CERTIFICATE OF APPROPRIATENESS PLACARD

403 ELM STREET
Address
OAKWOOD
Historic District
Historic Property
139-15-MW
Certificate Number
10/7/2015
Date of Issue
4/7/2016
Expiration Date

Install brick paver driveway;
 widen curb cut

Raleigh Historic Development Commission - Certificate of Appropriateness (COA) Application

403 Elm St – Drive Cut pictures

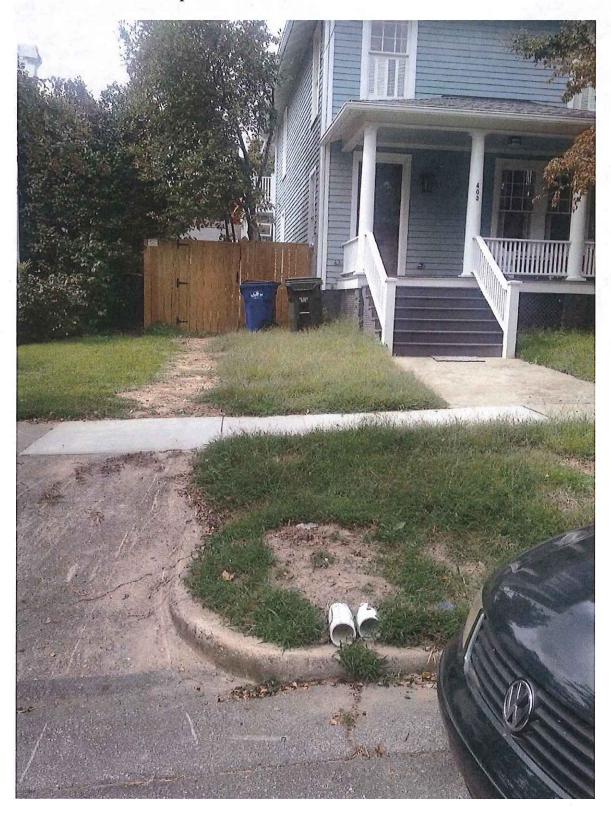
I've finally been able to closely review the amended COA application and need a bit of additional information. When we spoke I thought that you had provided a more detailed driveway drawing with dimensions, but I was remembering incorrectly.

-please confirm that the new curb curt will match the design of the addition -Include the dimension of the curb cut extension -please provide the widths of the driving strips and center portion.

The drawing I have is to scale (I know you have a reduction) so I will give you measurements from my copy.

My scale is 1" = 10 Feet

Each strip is 6/16 in Center is 10/16th in Curb cut is 3/8th in

The new curb will match the design in that it will line up perfectly with the areas around the strips for a symmetrical appearance.
